- This section is reissued to add information on the D5AM cord. The D5AM cord replaces the D5AF cord which is rated Manufacture Discontinued.
  - CIRCUIT DIAGRAM NOTES
  - Indicates current color code. Indicates MD color code.
  - Note 1: Dotted lines in diagram show manual set connections.
  - Note 2: New manufactured sets are wired as drawn. On converted 190 series sets, if the BR lead does not reach the BKX terminal, it is terminated on a BK terminal and a black strap connects BK and BKX,
  - Note 3: When a 61R filter is required for radio frequency suppression, move yellow dial lead from Y upper housing contact spring to filter bracket terminal and connect filter leads as follows:
    - Yellow lead to filter bracket terminal.
  - Black lead to BK or BKX upper housing contact.
  - · Red lead to Y upper housing contact.

Circuit diagram for connection with 685A network-type subscriber set.

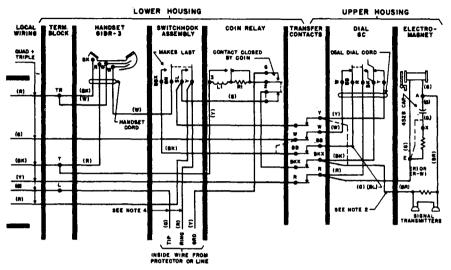
Note 4: When coin collector is installed in a KS-14611, List 2 booth or a KS-16705 mounting, the tip and ring line terminations are connected directly to the subscriber set.

Note 5: New manufactured sets are wired as shown in 2. To rearrange for use with 685B subscriber set, disconnect yellow strap between T terminal and coin relay and wire as shown in 3, Insulate and store yellow strap for future use.
